Work Order ID 135105

Item ID: D407-667-105 Accept ***N900040100*** Setup Start ***NS1***
Revision ID: Stop ***NS2***
Item Name: Fwd Crosstube - High 407
Start Date: 7/29/2015 Start Qty: 1.00 ***1*** Cust Item ID:
Required Date: 8/12/2015 Req'd Qty: 1.00 ***1*** Customer:
Reference:

DART AEROSPACE LTD		Work Order:	135105
Description: Crosstube High Fwd (407)		Part Number:	D407-667-105
Inspection Dwg: D407-667-145 Rev: C		Page 1 of 1

DRAWING NO. D407-667-145	TITLE CROSSTUBE ASS'Y (407 HIGH FWD)	REV. C	DART AEROSPACE LTD ENGINEERING ORDER		D.E.O. NO. D407-667-145-C-1	SHEET NO. SHEET 1 OF 1	SCALE NTS
DRAWN 40	CHECKED ASS	MFG. APPR. 18	APPROVED MD		DE APPR. H		
DATE 11.07.15	DATE 11.07.22	DATE 11.07.22	DATE 11/07/22		DATE 11.07.21

DETAIL P
BONDING STRAP INSTALLATION 2 PL

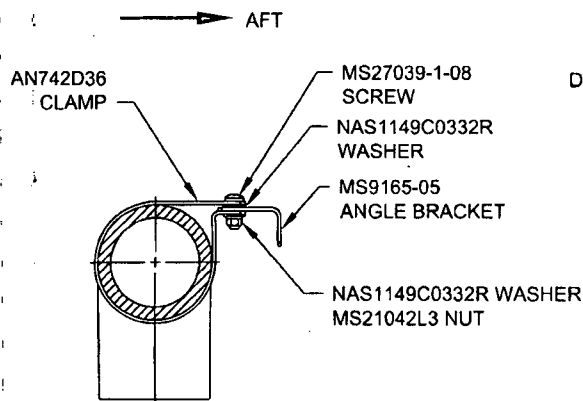
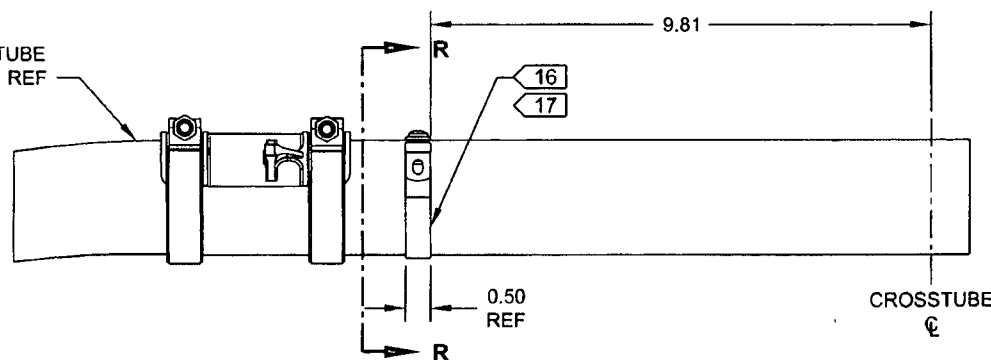
ADD ELECTRICAL GROUNDING STRAP

ADD

- 16) MASK AREA UNDER CLAMP PRIOR TO PAINTING
- 17) SEAL EDGES WHERE AN742D36 CLAMP MEETS WITH THE CROSSTUBE USING SIKAFLEX-241/-291 OR MIL-S-8802 CLASS B2 OR PROSEAL 890 SEALANT
- 18) PERFORM RESISTANCE CHECK TO ENSURE MAX RESISTANCE IS 10 MILLIOHMS
